CHANGE ORDER

No. One (1)

Project: Barber Road Bank Stabilization

WORK CHANGE DIRECTIVE

Attachments: (List documents supporting change) List of supporting documents.
Pages 3-4 - Mark-up plan sheets 8 & 11

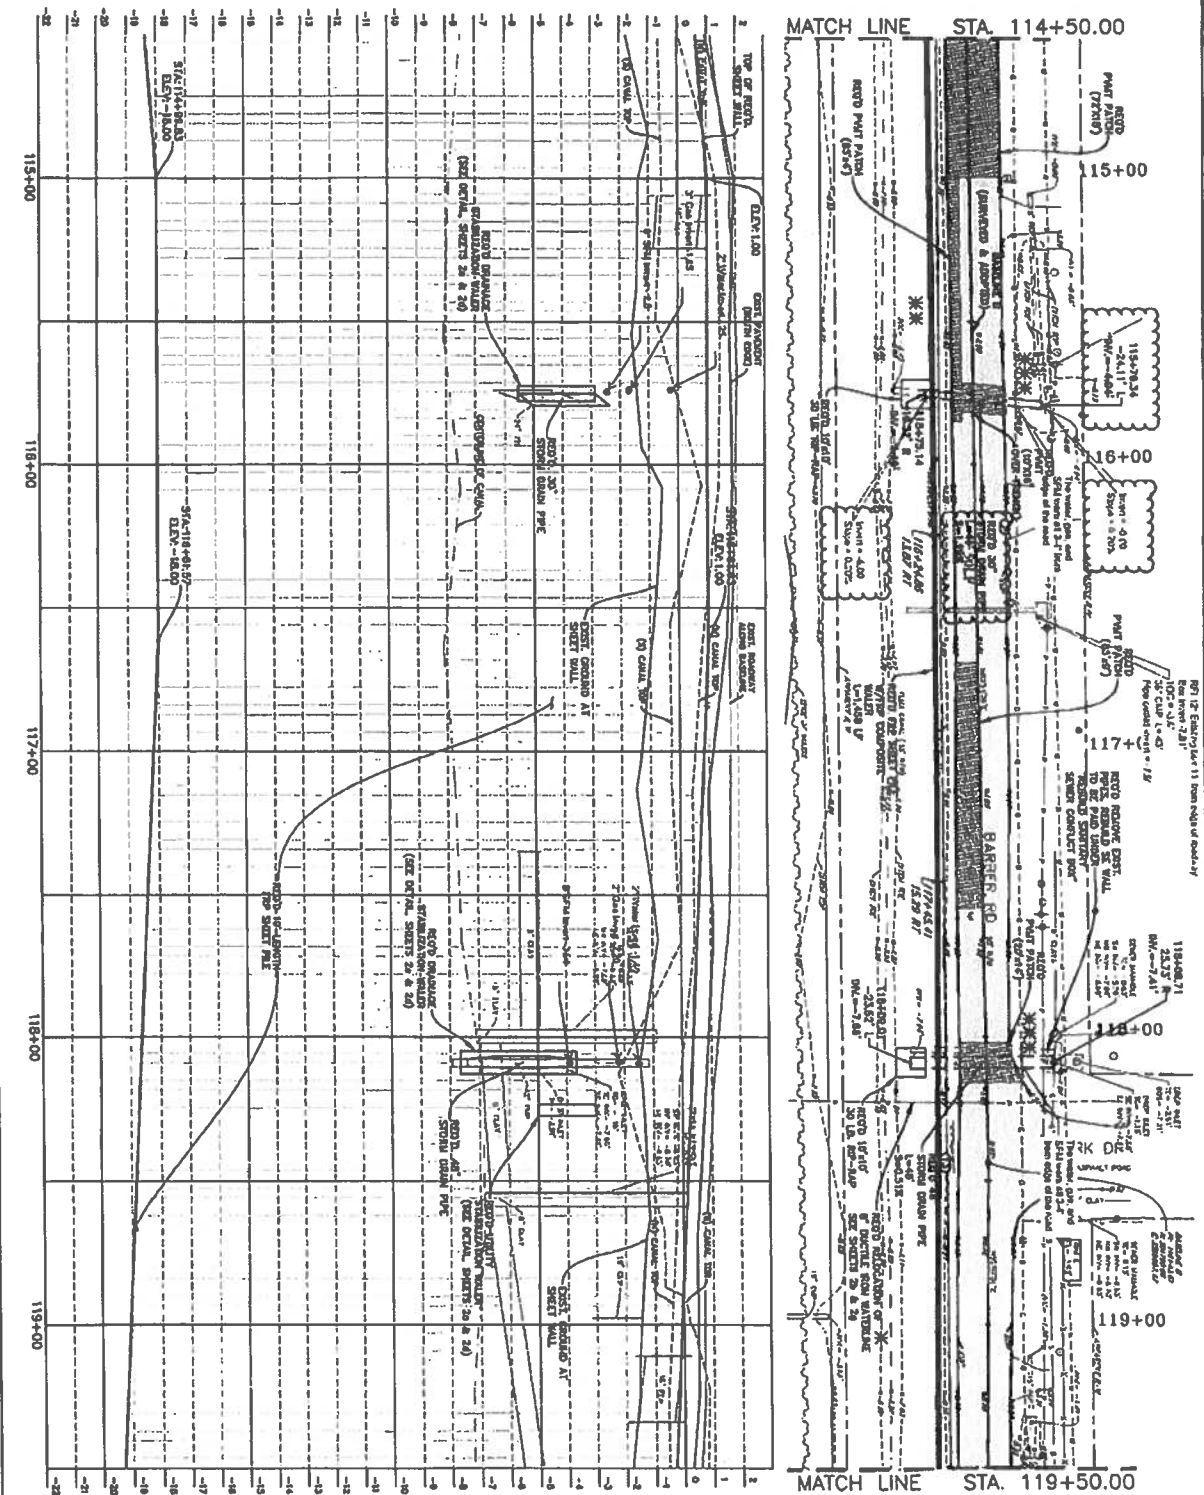
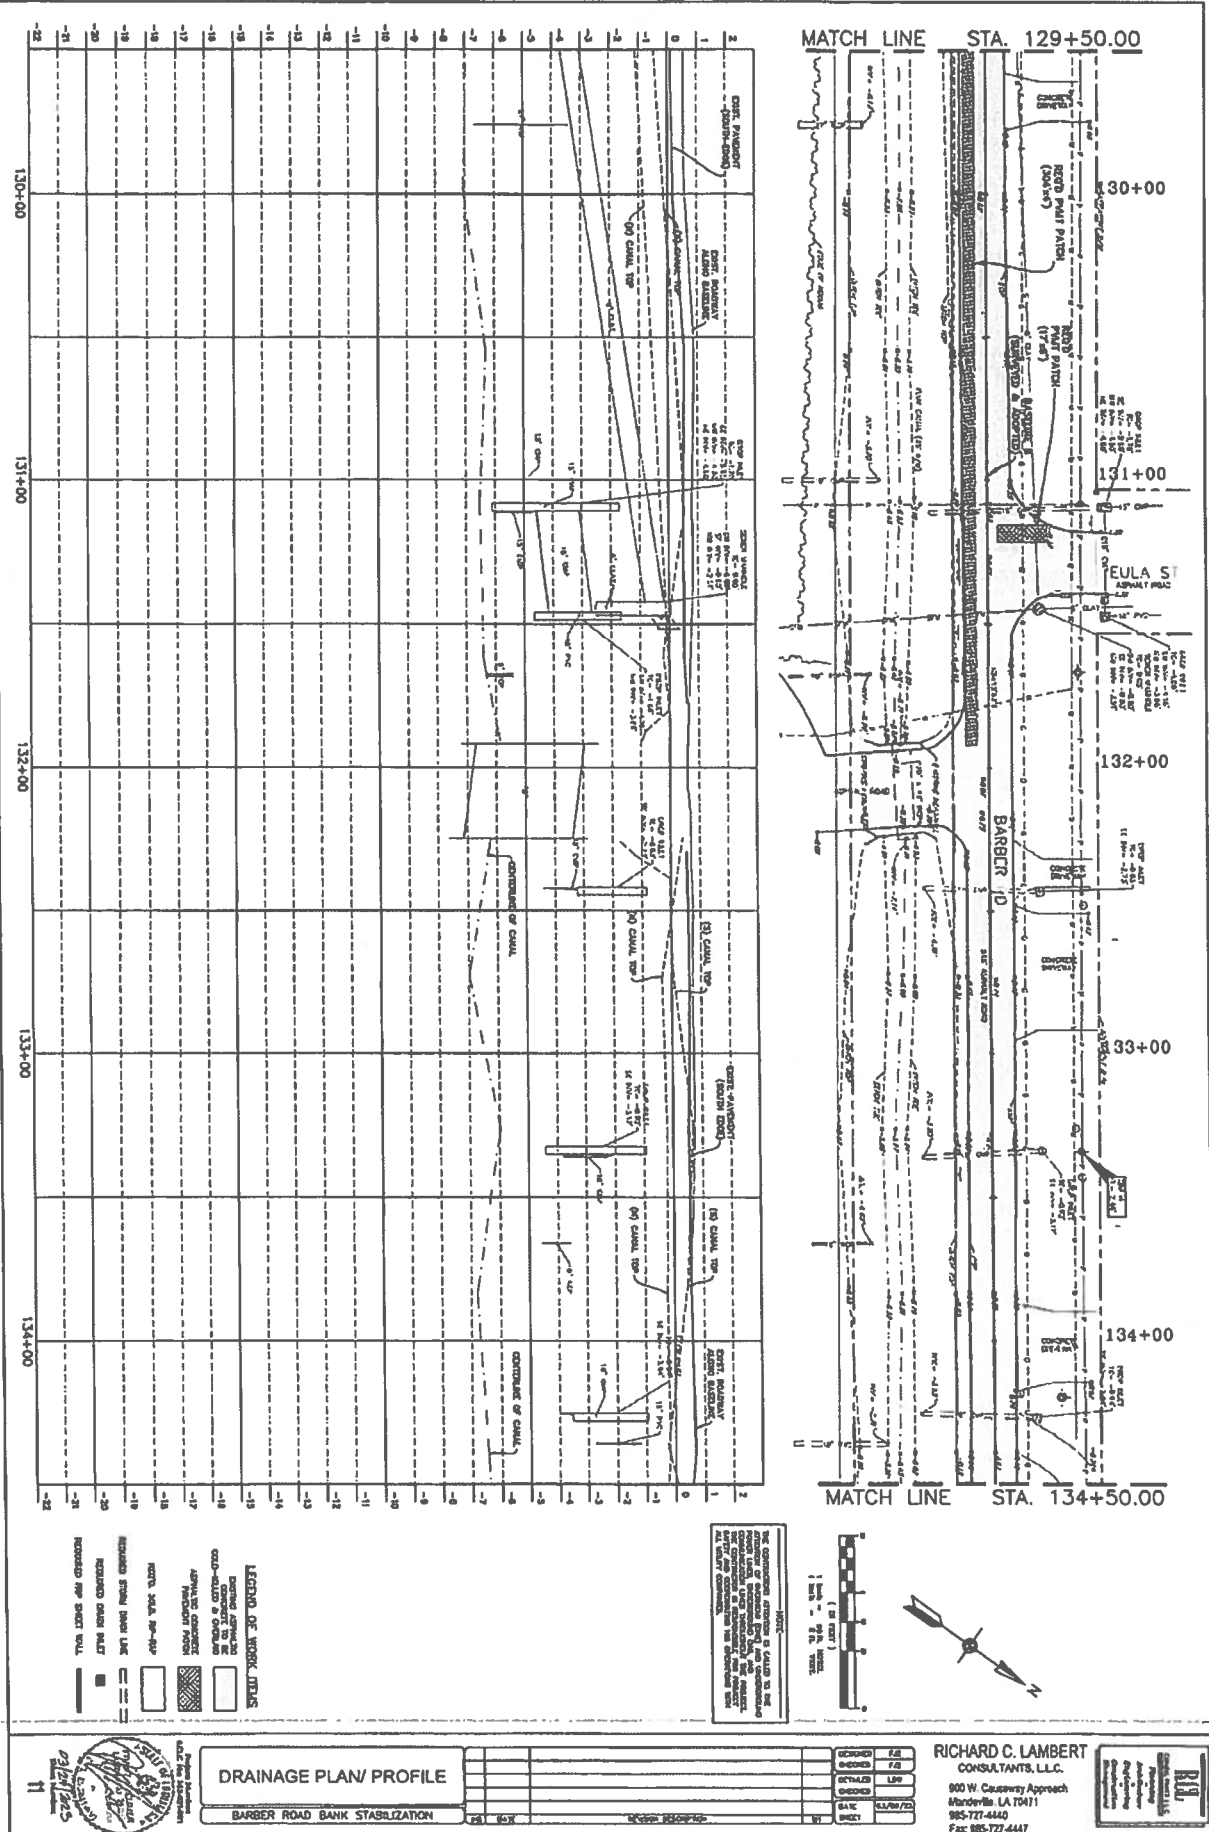
The cross drain at Sta. 132+42 was added to the project per SCP DPW during the pre-construction walk through due to the culvert being washed out. Additionally, at Sta. 115+79 the pipe was extended an additional 10 LF due to the pipe invert being adjusted to avoid conflicting utilities. 701-03-01022 - 18" STORM DRAIN PIPE (CPPPDW) - 50 LF (40 LF for Sta. 132+42 & 10 LF for Sta. 115+79)
711-01-00300 - RIP RAP (30 LB, 14" THICK) - 11.11 SY

- Page 2 : WCD #6 cost estimate spreadsheet
- Pages 3 - 7 : Command Change Order Request #4
- Page 8 : Conflict Box detail
- Page 9 : Mark-up plan sheet (Sta. 113+40 - Revision Cloud)

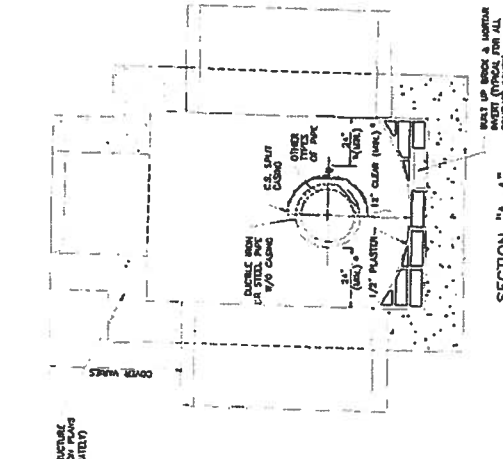
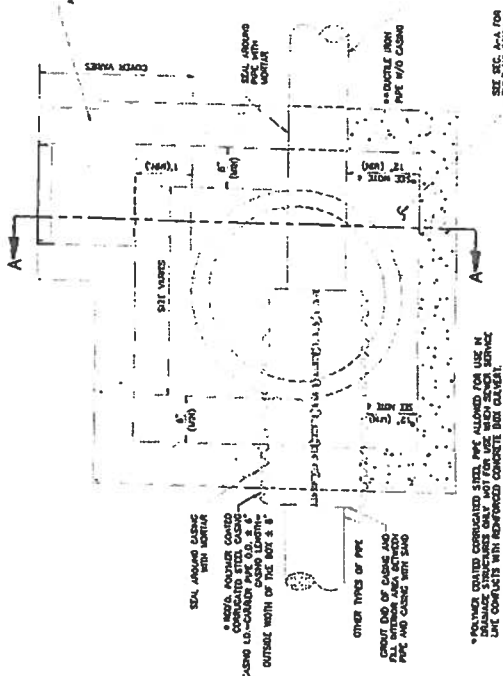
Description: Enter description of changes for Contractor.
In reference to RFI #5 & COR #4, Command is directed to replace the existing D.I. with a conflict box(Brick or CIP) using bituminous coated corrugated steel split casing around the existing sewer house connection and tie in existing 15" RCP drainage to new conflict box. Split casing to be 8" min (up-sized from existing 6" sewer line). In addition, replace the existing 24" PVC drain line with 24" STORM DRAIN PIPE (CPPPDW) in lieu of the proposed 30" Pipe to avoid existing SFM and gas line utility conflicts.

- CONFLICT NOTES:**
1. SPLIT CASING SHALL BE PROVIDED COATED (DUAL/UNL.) IN ACCORDANCE WITH AASHTO SPECIFICATIONS L-114, L-118 AND L-119 18 CASE.
 2. IF ANY OTHER TYPE OF CASING IS USED, THE UPPER END OF THE CASING SHALL BE PROTECTED BY A 3/16" GALV. STEEL PLATE AS SHOWN IN THE DRAWING SUBJECT TO THE APPROVAL OF THE PROJECT ENGINEER.

3. ALL WATER LINES IN CONTACT BOX SHALL BE DUCTILE IRON PIPE. OTHER PIPE MATERIALS SHALL BE INSTALLED IN SPLIT CASING.
 4. CLEARANCES SHOWN ARE NOT FOR PROTECTIVE DESIGN PURPOSES, BUT ARE USUALLY SUFFICIENT TO PROVIDE PROPER PROTECTION AND MAINTENANCE OF THE CASING. THE 18" CLEARANCE FROM THE CENTER OF THE CASING TO THE SURFACE OF THE CASING SHALL BE MAINTAINED TO THE ENTIRE LENGTH OF THE CASING. THE CASING SHALL BE PROTECTED AND MAINTAINED BY PROVIDING PROTECTIVE COATING TO THE ENTIRE LENGTH OF THE CASING. ALL CLEARANCES AND APPROXIMATE CONTACT POINTS SHALL BE IDENTIFIED WITH AND SHOWN FOR THE OTHER LINES IN CONTACT.

5. THE PROTECTED METHOD OF INSTALLING SPLIT CASING IS TO HAVE THE FLANGES IN CONTACT WITH EACH OTHER AS SHOWN IN S.D.C. 1-14.
